Work Order ID 84557

Item Name: Crosstube Aft

Reference: rework- ECN11-614

DRAWING NO. D212-664-241	TITLE CROSSTUBE ASSY (205/212 HI AFT)	REV. D	DART AEROSPACE LTD. ENGINEERING ORDER		D.E.O. NO. D212-664-241-D-1	SHEET NO. SHEET 1 OF 2	SCALE NTS
DRAWN	CHECKED	MFG. APPR.	APPROVED	DE APPR.			
DATE 11.04.07	DATE 11.04.11	DATE 11.04.12	DATE 11/04/12	DATE 11.04.12

FIGURE 1: SUPPORT INSTALLATION

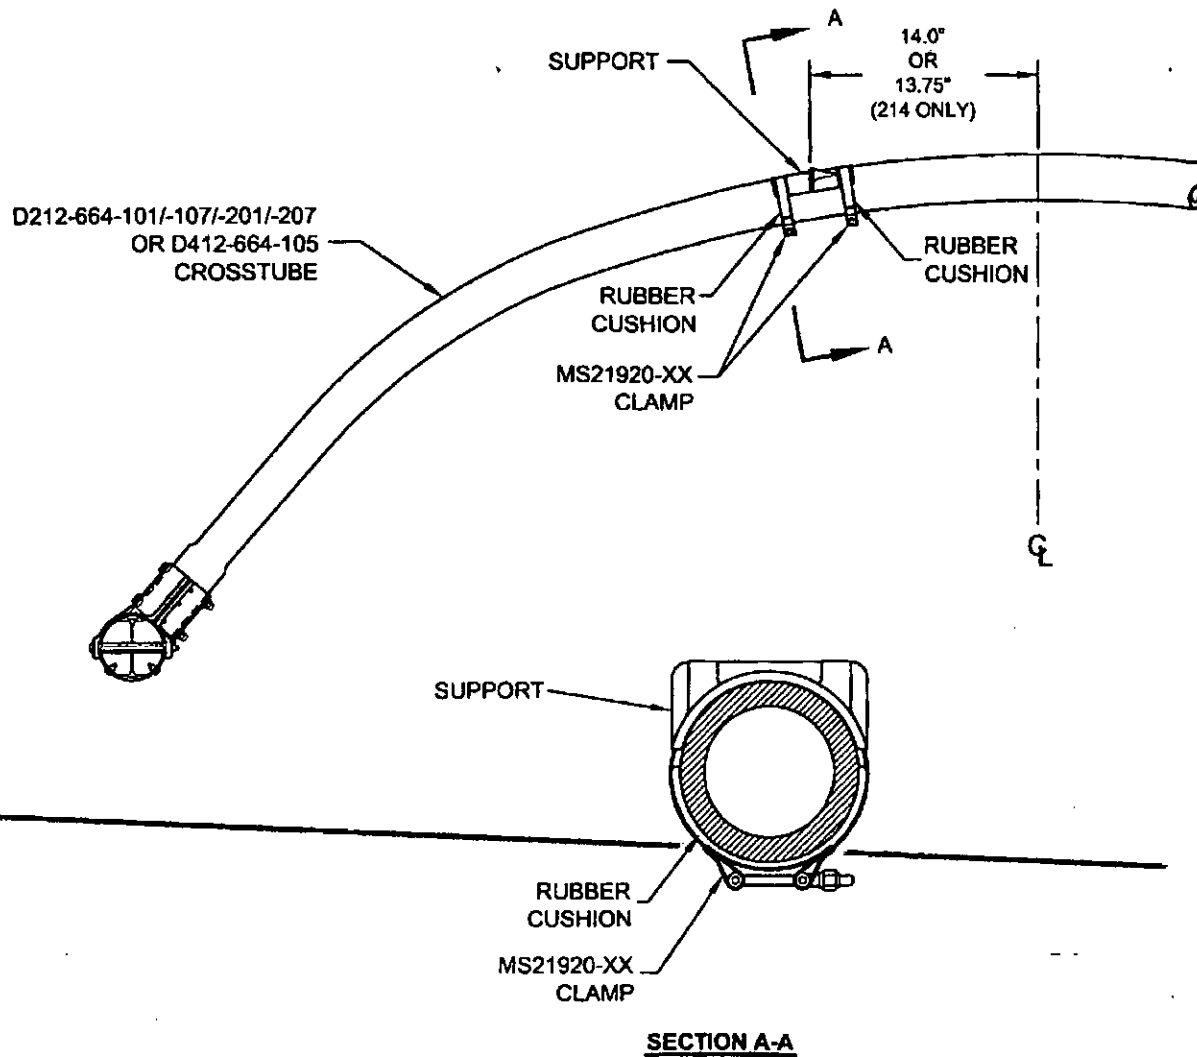
The supports on the following crosstubes are now installed using Proseal instead of Magnobond:

For the crosstubes listed above, section 32.4 of ICA-D212-664 is amended as follows. Use Figure 1 of this service instruction and Figures 32-2 to 32-9 of ICA-D212-664 for further reference. For crosstubes of an earlier change number, it is recommended that if the supports are removed, the supports should be reinstalled using the procedure listed below.

32.4.5 Apply a 0.04" to 0.07" thick layer of Proseal 890 Class B or AMS-S-8802 Class B sealant underneath applicable support and install support as shown in Figure 1 of this service instruction.

32.4.6 Install the clamps opposite to crosstube support as shown in section A-A of Figure 1. Install rubber cushions underneath each clamp around the bottom circumference of the crosstube up to the crosstube centerline. Torque clamps 80-100 in-lb (9.0-11.3 Nm). It is acceptable to use smaller or larger sized MS21920-XX clamps than those listed in ICA-D212-664, ensure that after torquing the clamps per this instruction, the nuts are in safety but not bottomed out

**D212-664-241/-241B
ASSEMBLY DETAIL**

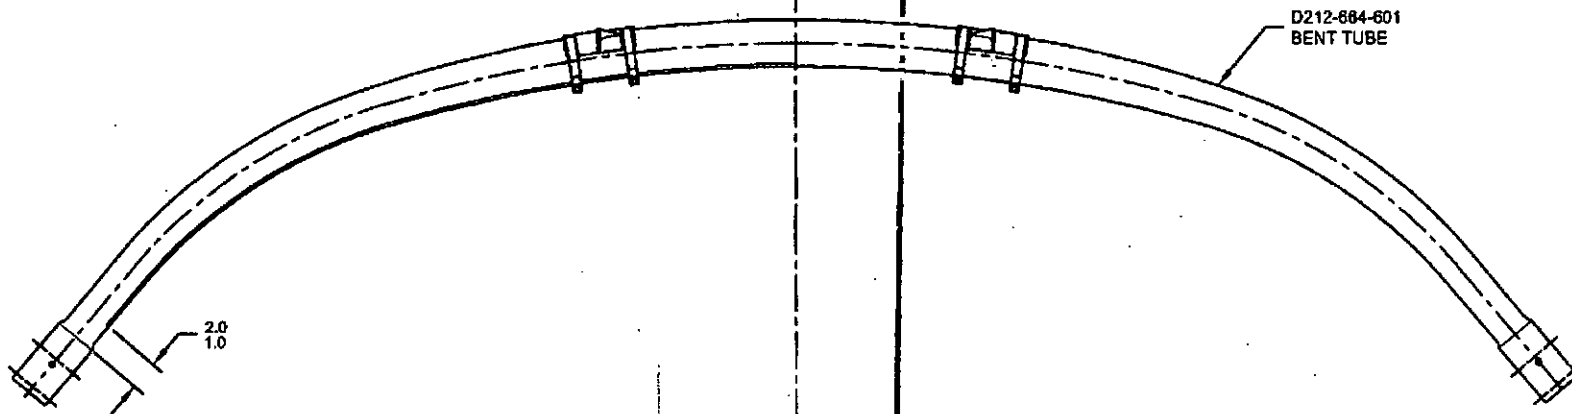
PURPOSE:

ADD AN INSPECTION WINDOW TO UNDERSIDE OF CROSSTUBE.

MASK AREA PRIOR TO PAINTING,
REMOVE MASKING AFTER PAINT
AND APPLY CLEAR COAT

- 2) FINISH: CHEMICAL CONVERSION COAT PER DART QSI 005 4.1
PRIME INSIDE AND OUTSIDE PER DART QSI 005 4.2
MASK UNDERSIDE OF CROSSTUBE AS SHOWN (HATCHED AREA) AND
PAINT OUTSIDE PER DART QSI 005 4.2
REMOVE MASKING AND APPLY CLEAR COAT
